Office Action Summary

10/782,656

MCCARTHY, ROBERT

DETAILED ACTION

Fig. 1

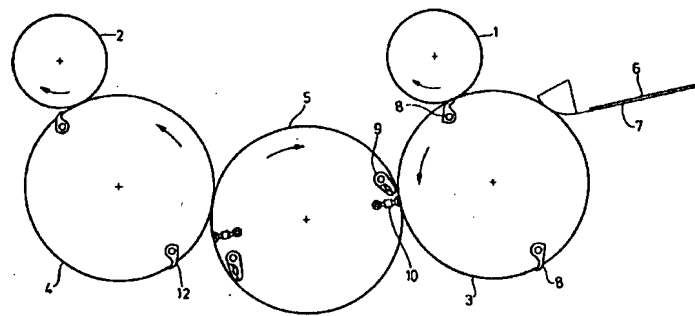
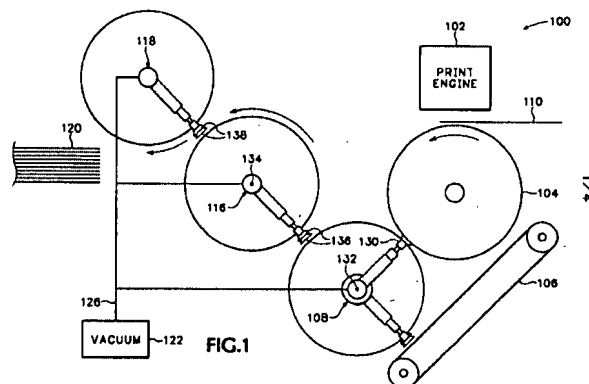
Claims 1-2, 4, 6, 12-15, and 16 are rejected under 35 U.S.C. 103(a) as being unpatentable over Helmstaedter, et al. (U.S. 5,454,312) ("Helmstaedter") in view of Krueger (U.S. 2,231,339) and further in view of Tajima (JP 62-215441) and Hudson et al. (U.S. 2004/0113349) ("Hudson"). Helmstaedter discloses:

Claims 1 and 4: support (See Fig. 1, concentric circles on 10); cups (10);

Claim 1: distal surfaces (10); conveyor (4); drum (3);

Claims 6 and 15: at least four suction members (Fig. 3);

Helmstaedter does not directly show a first plane, a second plane, at least four suction members arranged with the middle cups being in the first plane and the outer cups in the second plane, or a liquid electrophotography print engine.
